Proposal for the 01 series amendments to new ECE Regulation on pedestrian safety

Submitted by the expert from Japan*

Figure 2: FlexPLI; Dimensions and C.G. locations of femur, knee joint, and tibia (Side view)

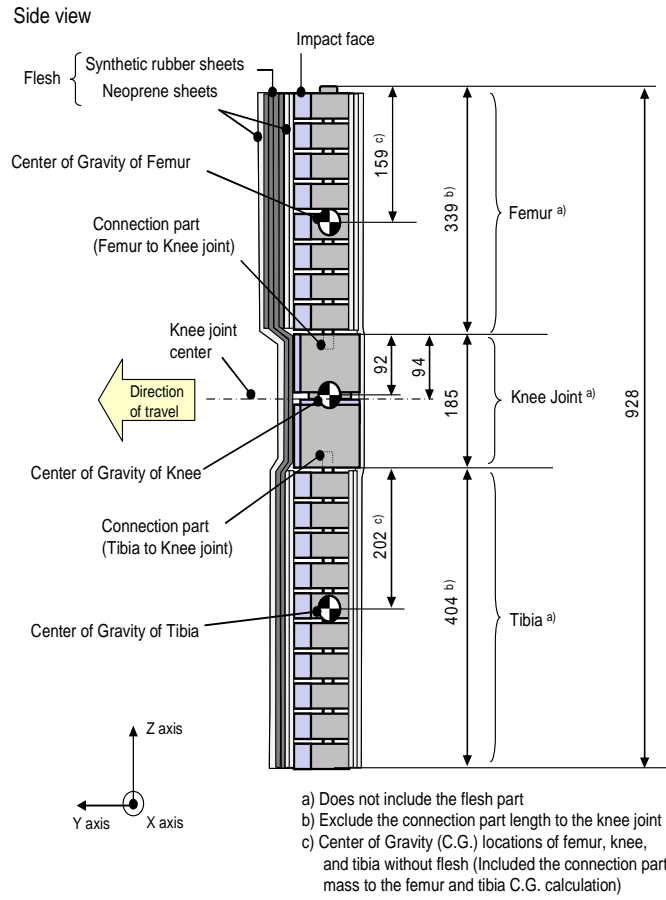
1.3.1. **The lower legform impactor shall consist of flesh, flexible long bone segments (representing femur and tibia), and a knee joint as shown in Figure 2.**

The overall length of the impactor shall be 928 ± 3 mm, having a required mass of 13.2 ± 0.7 kg including flesh. The length of the femur, knee joint, and tibia shall be 339 ± 2 mm, 185 ± 1 mm, and 404 ± 2 mm respectively. The knee joint centre position shall be 94 ± 1 mm from the top of the knee joint.

The centre of gravity of the femur and tibia without flesh, including the connection part to the knee joint, shall be 159 ± 8 mm and 202 ± 10 mm respectively from the top, but not including the connection part to the knee joint, of each part as shown in Figure 2. The centre of gravity of the knee joint shall be 92 ± 5 mm from the top of the knee joint as shown in Figure 2.

Figure 3: FlexPLI; femur, tibia, and knee dimensions (Top view)

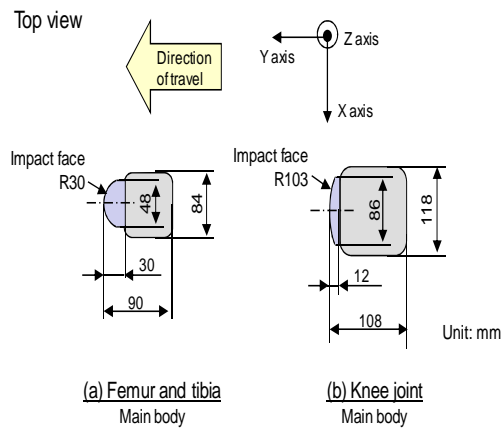
1.3.2. **The cross-sectional shape perpendicular to the Z axis of the femur and tibia main bodies shall be 90 ± 2 mm in width along the Y axis, and 84 ± 1 mm in width along the X axis as shown in Figure 3 (a). The impact face shall be 30 ± 1 mm in radius, 30 ± 1 mm in width along the Y axis, and 48 ± 1 mm in width along the X axis as shown in Figure 3 (a).**

1.3.3. **The cross-sectional shape perpendicular to the Z axis of the knee joint shall be 108 ± 2 mm in width along the Y axis, and 118 ± 1 mm in width along the X axis as shown in Figure 3 (b). The impact face shall be 103 ± 1 mm in radius, 12 ± 1 mm in width along the Y axis, and 86 ± 1 mm in width along the X axis as shown in Figure 3 (b).**

Figure 4: FlexPLI; flesh dimensions

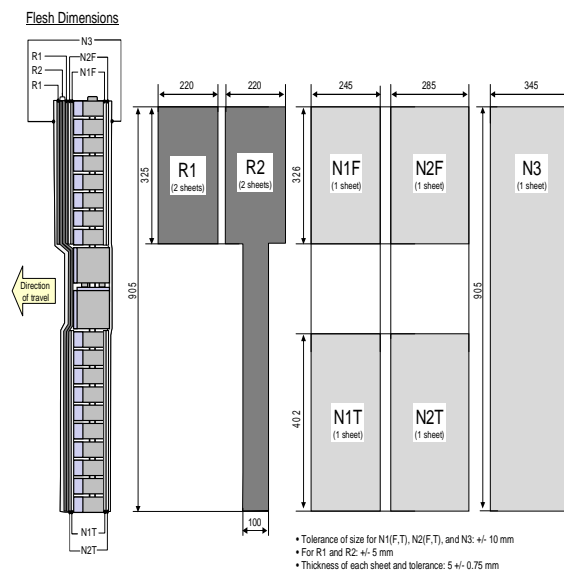
- 1.3.5. For each test, the impactor (femur, knee joint, and tibia) shall be covered by flesh composed of synthetic rubber sheets (R1, R2) and neoprene sheets (N1F, N2F, N1T, N2T, N3) as shown in Figure 4. The sheets are required to have a compression characteristic as shown in Figure 5. The compression characteristic shall be checked using the same batch of sheets as those used for the impactor flesh. The size of the sheets shall be within the requirements described in Figure 5.

Figure 3: Tolerances of angles for the lower legform impactor at the time of the first impact (see paragraphs 1.2.2. and 1.2.3.2.)

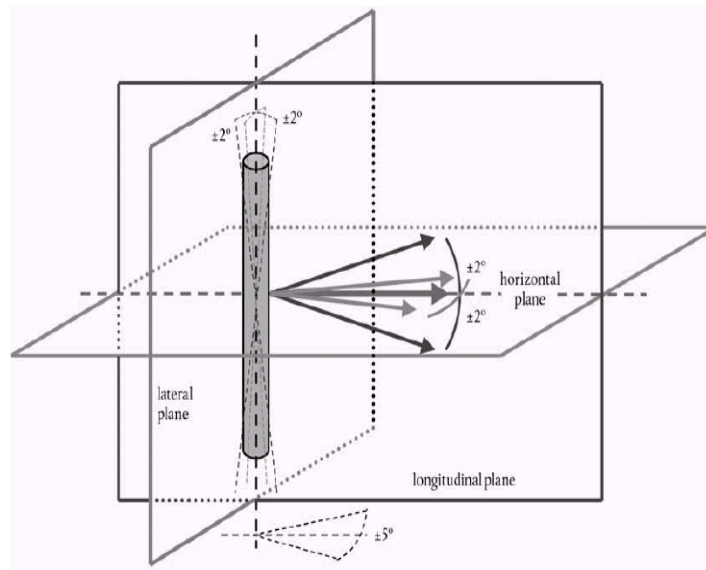
1.2.2. The direction of the impact velocity vector shall be in the horizontal plane and parallel to the longitudinal vertical plane of the vehicle. The tolerance for the direction of the velocity vector in the horizontal plane and in the longitudinal plane shall be $\pm 2^\circ$ at the time of first contact. The axis of the impactor shall be perpendicular to the horizontal plane, with a roll and pitch angle tolerance of $\pm 2^\circ$ in the lateral and longitudinal plane. The horizontal, longitudinal and lateral planes are orthogonal to each other (see Figure 3).

1.2.3.2. At the time of first contact the impactor shall have the intended orientation about its vertical axis, for the correct operation of its knee joint, with a yaw angle tolerance of $\pm 5^\circ$ (see Figure 3).

Figure 4: FlexPLI to bumper tests for complete vehicle in normal ride attitude (left) and for cut-body mounted on supports (right) (see paragraph 1.2.3.)”

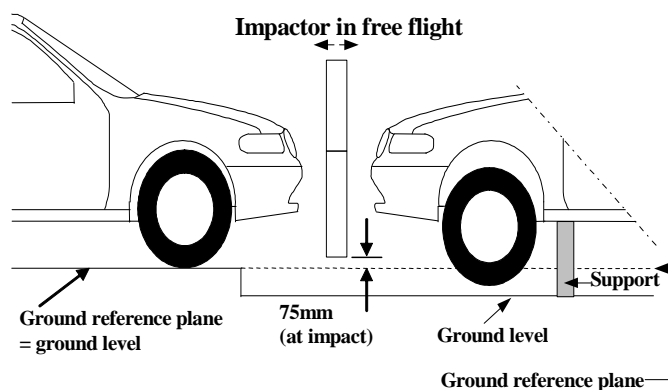
1.2.3. The bottom of the impactor shall be at 75 mm above ground reference plane at the time of first contact with the bumper (see Figure 4), with a ± 10 mm tolerance. When setting the height of the propulsion system,

Figure 7: Requirement corridor of femur and tibia in static certification test (see paragraph 1.2.2.2.)

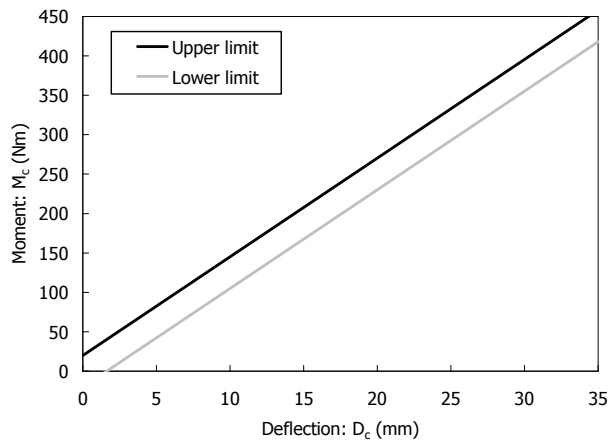
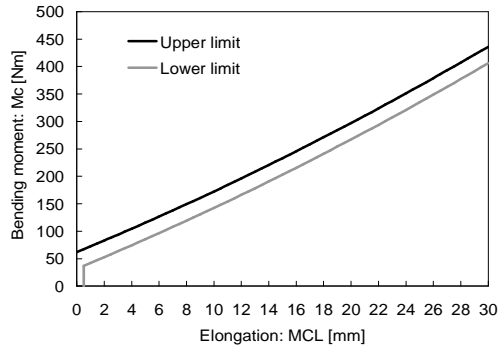
1.2.2.2. When the femur and tibia of the impactor are loaded in bending in accordance with paragraph 1.2.2.4., the applied moment and generated deflection at the centre of the femur and tibia (M_c and D_c) shall be within the corridors shown in Figure 7.

Figure 8: Requirement corridors for knee joint in static certification test (see paragraph 1.2.2.3.)

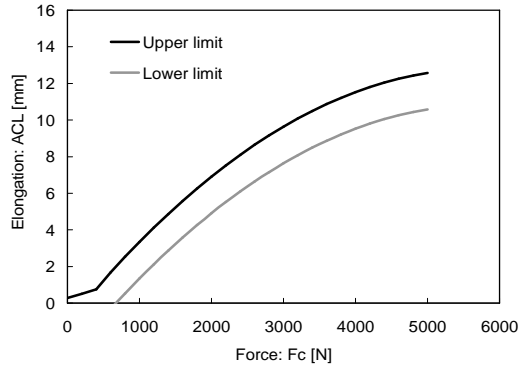
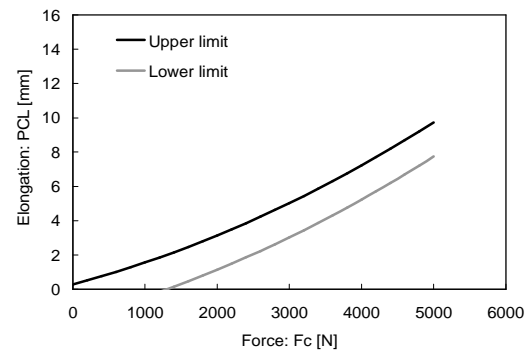
1.2.2.3. When the knee joint of the impactor is loaded in bending in accordance with paragraph 1.2.2.5., the MCL, ACL, and PCL elongations and applied bending moment or force at the centre of the knee joint (M_c or F_c) shall be within the corridors shown in Figure 8.

Figure 9: Test set-up for femur in static certification tests (see paragraph 1.2.2.4.)

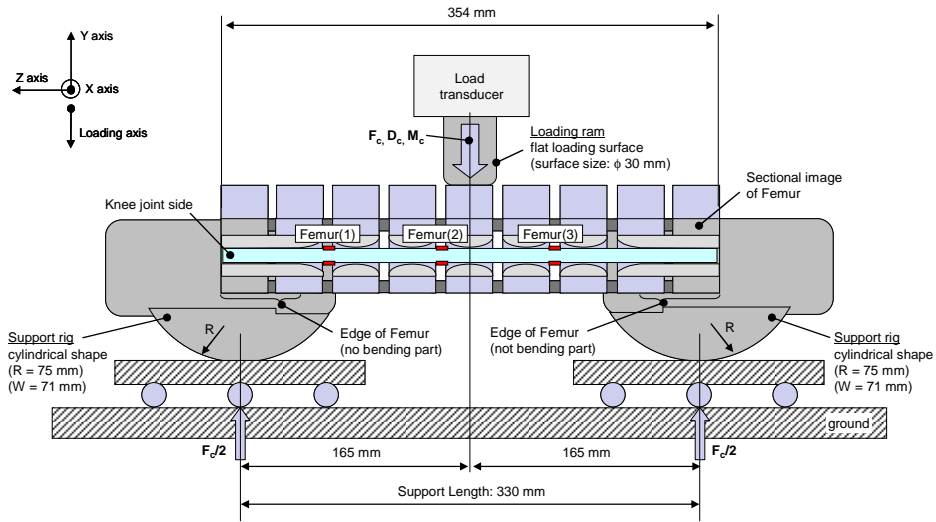
1.2.2.4. The edges of the femur and tibia, not bending parts, shall be mounted to the support rig firmly as shown in Figure 9 and Figure 10. The Y axis of the impactor shall be parallel to the loading axis within $180 \pm 2^{\circ}$ tolerance. In order to avoid friction errors, roller plates shall be set underneath the support rigs.

The centre of the loading force shall be applied at the centre of the femur and tibia within $\pm 2^{\circ}$ tolerance along the Z axis. The force shall be increased at a rate between 10 and 100 mm/minute until the bending moment at the centre part (M_c) of the femur or tibia reaches 400 Nm.

Figure 13: Test set-up for dynamic lower legform impactor certification test, Inverse type (see paragraph 1.2.4.4)."

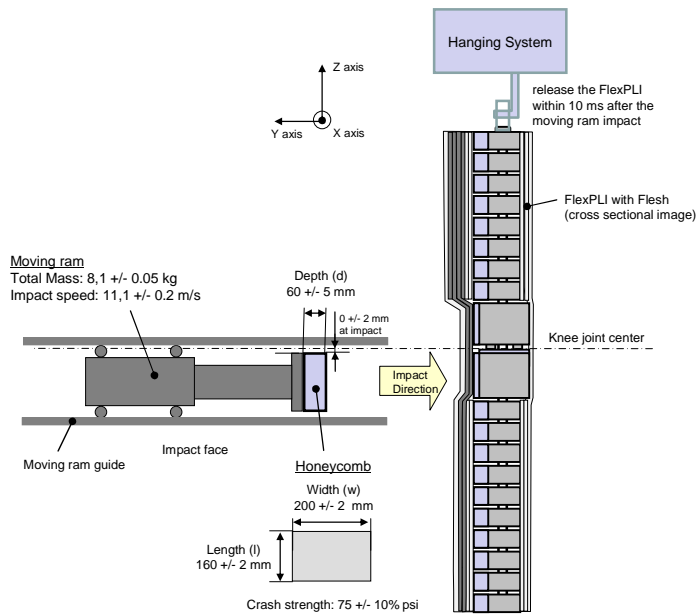
- 1.2.4.4. Test procedure
- 1.2.4.4.1. The fully assembled FlexPLI (with flesh and skin) shall be stationary suspended vertically from a test rig as shown in Figure 13. It is then impacted by the upper edge of a linearly guided Al honeycomb impactor, covered by a thin (less than 1 mm thickness) paper cloth, at an impact speed of $11,1 \pm 0,2$ m/s. The legform is to be released from the test rig within 10 ms after the time of first contact to ensure a free flight condition.

- 1.2.4.4.2. The honeycomb of 5052 alloy, which is attached in front of the moving ram, shall have a crash strength of 75 ± 10 per cent psi and dimensions of $w = 200 \pm 2$ mm, $l = 160 \pm 2$ mm and $d = 60 \pm 5$ mm. To ensure a consistent and good level of repeatability, the honeycomb should either have a 3/16 inches cell size in combination with a density of 3.1 pcf or a 1/4 inches cell size in combination with a density of 2.3 pcf or a 3/16 inches cell size in combination with a density of 2.0 pcf.

- 1.2.4.4.3. The upper edge of the honeycomb face is to be in line with the rigid plate of the linearly guided impactor. At time of first contact, the upper edge of the honeycomb is to be in line with the knee joint centre line within a vertical tolerance of 0 ± 2 mm. The honeycomb shall not be excessively handled or deformed before the impact test.

- 1.2.4.4.4. The FlexPLI pitch angle and therefore the pitch angle of the velocity vector of the honeycomb impactor (rotation around y-axis) at the time of first contact shall be within a tolerance of $0 \pm 2^\circ$ in relation to the lateral vertical plane. The FlexPLI roll angle and therefore the roll angle of the honeycomb impactor (rotation around x-axis) at the time of first contact shall be within a tolerance of $0 \pm 2^\circ$ in relation to the longitudinal vertical plane. The FlexPLI yaw angle and therefore the yaw angle of the velocity vector of the honeycomb impactor (rotation around z-axis) at the time of
